From: Snyder, Amy
To: Maloney, Moira
Cc: Barr, Cynthia; Chapman, Greg; Warner, Katherine; Watson, Bruce
Subject: FW: follow-up questions West Valley Air Modeling
Date: Thursday, December 9, 2021 1:28:00 PM
Attachments:

To prepare for the upcoming call with NRC, please see the Follow-up Questions on AERMOD Modeling for DOE West Valley that we plan to ask during the call:

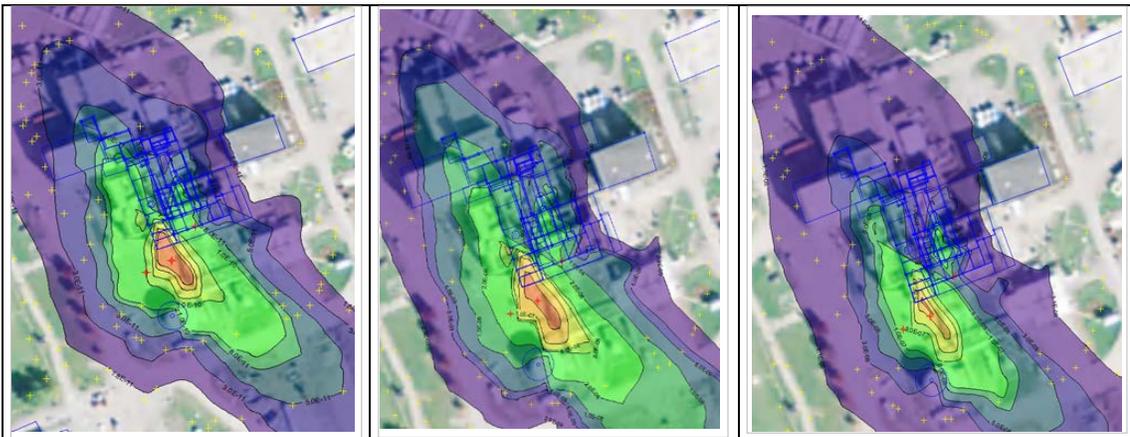
- 2. Particle size can have a significant influence on environmental transport and biosphere calculations (see Table 1 sensitivity analysis results).** The relevance of the MacMillan study for demolition activities at the WVDP site should be discussed to provide support for the assumed values, or a sensitivity analysis should be conducted to illustrate the reasonableness of the assumed particle sizes. A comparison of demolition activities and controls (e.g., types of fixatives) in the MacMillan study versus the WVDP planned demolition activities would also help to provide support for assumptions regarding particle size in the AERMOD simulations for various types of demolition activities. The NRC staff would note that literature cited in the MacMillan study for hot cutting activities support smaller submicron particle diameters, which calls into question the use of a single set of particle sizes for all WVDP demolition and dismantlement activities. Please explain how uncertainty in the particle size distributions is considered during biosphere and air transport modeling.

- a. What is was the basis for the particle size density of 1.0?
 - b. What is the basis for using the largest particle size for each bin?
 - c. Was there any effort to study the impact of particle size of the AERMOD calculations?

- d. How is the approach used expected to be realistic or conservative (e.g., larger particle sizes lead to higher concentrations closer to the source but a smaller overall footprint; smaller particle sizes would lead to greater offsite impacts)?
